Streetwork compliance report (Video ID: test_video_1)

BARRIER_CONTINUITY evidence frames

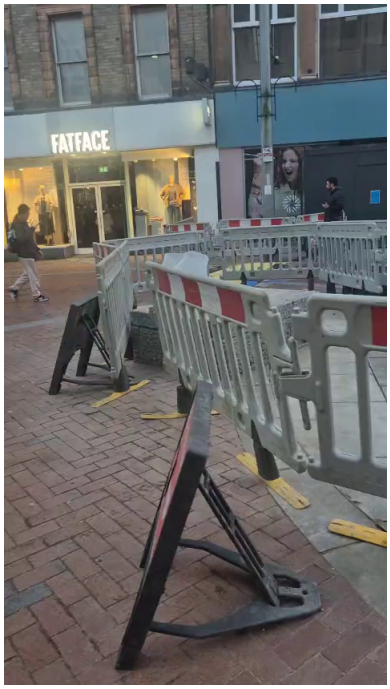
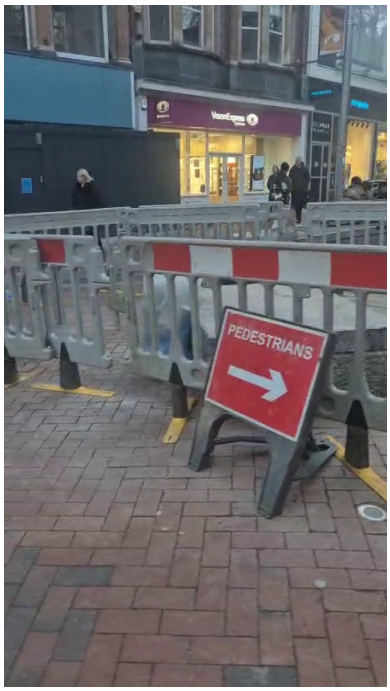
BARRIER_CONTINUITY - Not Compliant

- [00:00 - 00:07] (high) There is a noticeable gap between the first and second barricade units, compromising the continuity of the barrier system.

- Verify that each unit is locked and properly aligned.
- Inspect signage compliance and enforce penalties for violations.
- Ensure all pedestrians comply with high-vis vest and hard hat requirements.
- Inspect the connection points between units to guarantee integrity.
- Verify that the signage complies with UK standards regarding size, color, and placement.
- Ensure the signage is clearly visible and legible by improving lighting or positioning.
- Provide training on mandatory PPE regulations.
- Ensure all barricade units are securely connected without any gaps.

CHAPTER_8_SIGNAGE evidence frames

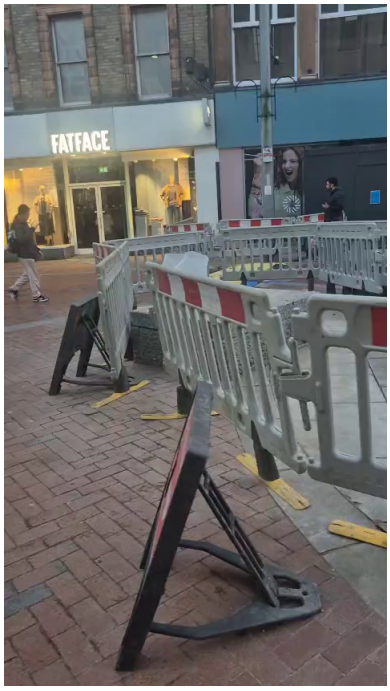
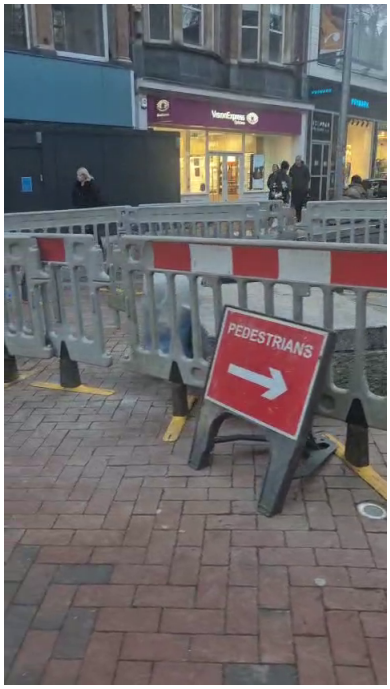
CHAPTER_8_SIGNAGE - Not Compliant

- [00:00 - 00:07] (low) The signage is present but lacks clarity due to poor visibility.
